City of Ryde Submission 6-8 Julius Avenue North Ryde - SSDA Julius Avenue Data Centre

SSD-80018208

**Submission Date: 27 August 2025
COR2025/262/1**

Figure 8: Extract shown in Yellow showing pipe asset extending the property boundary.

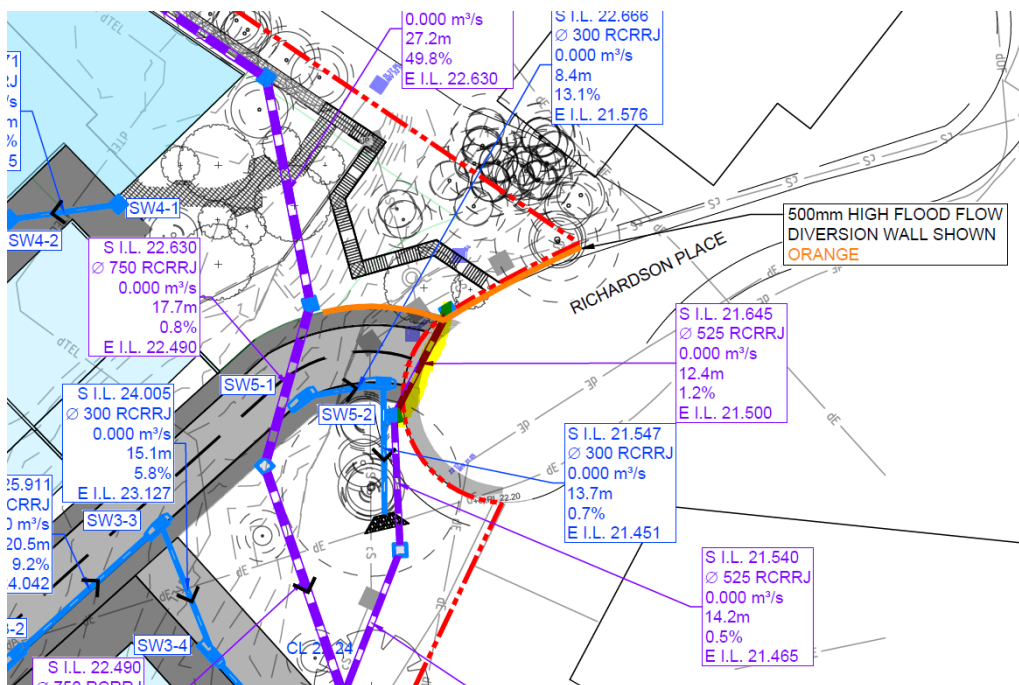
Council recommends that the *Stormwater plans (Revision D) prepared by TTW Pty Ltd dated 11 July 2025* are to be revised noting that Richardson Place is currently a private road; therefore, a proposed pipe system within a privately owned road cannot be supported without the asset owner's authority.

It is recommended that the Applicant revise the design to:

- Indicate the ownership of the proposed access road on the plans. Council's preference is for this road to be maintained by private owners, as it services only this development. Council will not accept maintenance responsibility for the OSD system.
- Indicate the existing Council drainage assets with a different layer. There are some details such as the existing pit on the Richardson place corner missing on the plan.
- Owners consent would be required from 3 Richardson Avenue to propose works within their lot.

Figure 10: Extract showing Council's current PMF Mapping (Source: Ryde Maps)

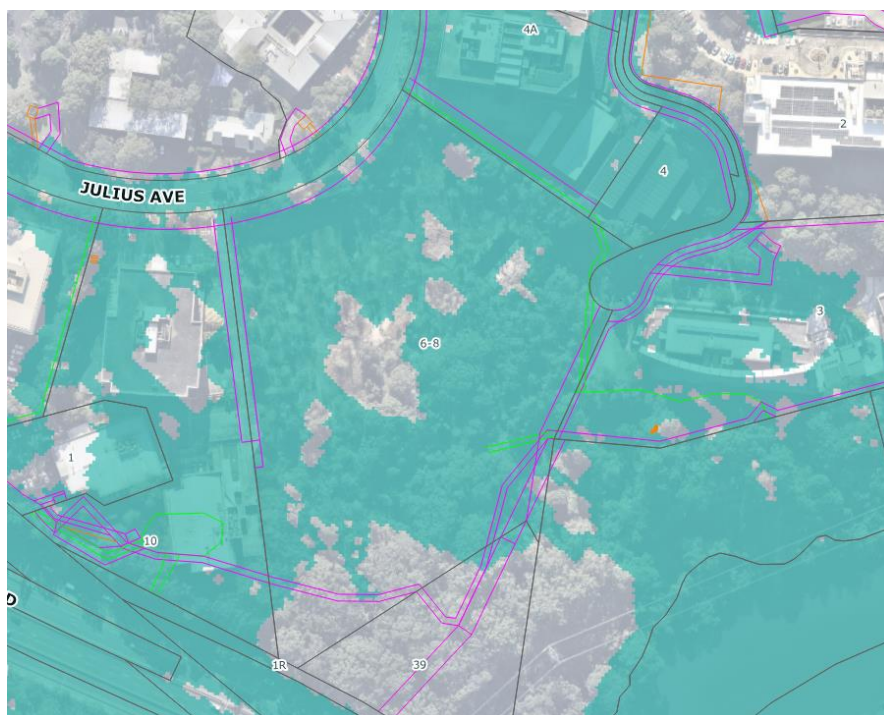
The existing Council flood maps indicates that the site is 100% inundated by PMF flood. Please note that reference must be made to the existing flood maps, as the draft flood study is not yet legally gazetted. Accordingly, the following highlighted statement must be revised in line with existing flood mapping:

As the site is affected by PMF, the architectural plans will require amendment to address the following points:

- Basement Ramp/opening to raise to PMF level before descending to the basement to ensure basement flood immunity.
- A cross section of the basement ramp/opening to be provided and clearly demonstrate that the crest of the basement ramp is designed up to PMF level.
- Any other opening leading to the basement (e.g. emergency exits, vents, etc.) to be located above PMF.
- Please provide the certificate from the flood engineer that the proposed basement openings are not inundated during PMF flood event.
